LEO
V2.800.0000000.21.R.201124

Release Notes

ZHEJIANG DAHUA VISION TECHNOLOGY CO., LTD.

Figure 1-2 Delete scene changing

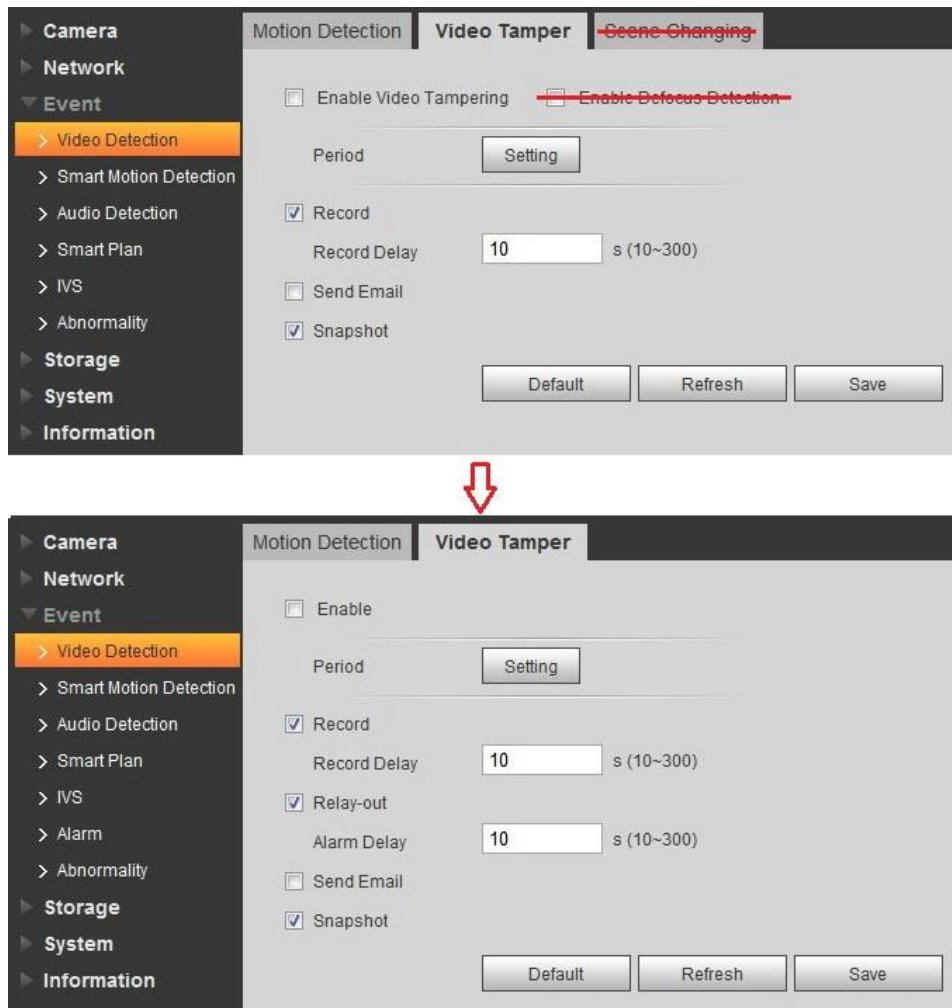
- Because of the storage shortage of the series 32 devices after SMD and IVS optimization, scene changing and defocus detection functions are deleted.

Figure 1-3 Legal information on web

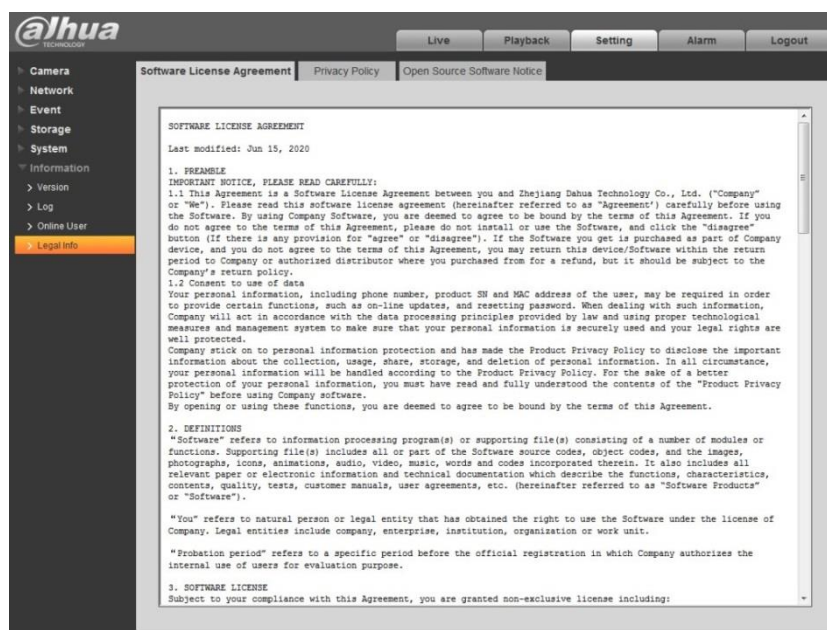
As the company requirements of device compliance, software license agreement, private policy and open source software notice need to be displayed on the device.

Figure 1-4 Disabled (default) audio

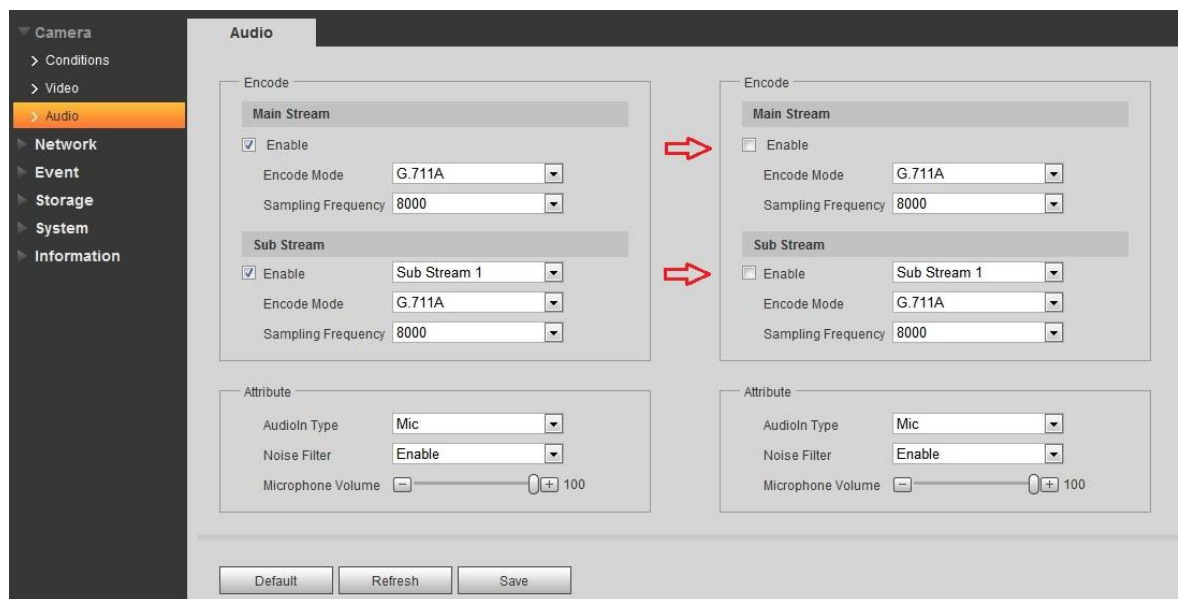
Audio is disabled by default, because collecting audio without informing others is illegal in some areas.
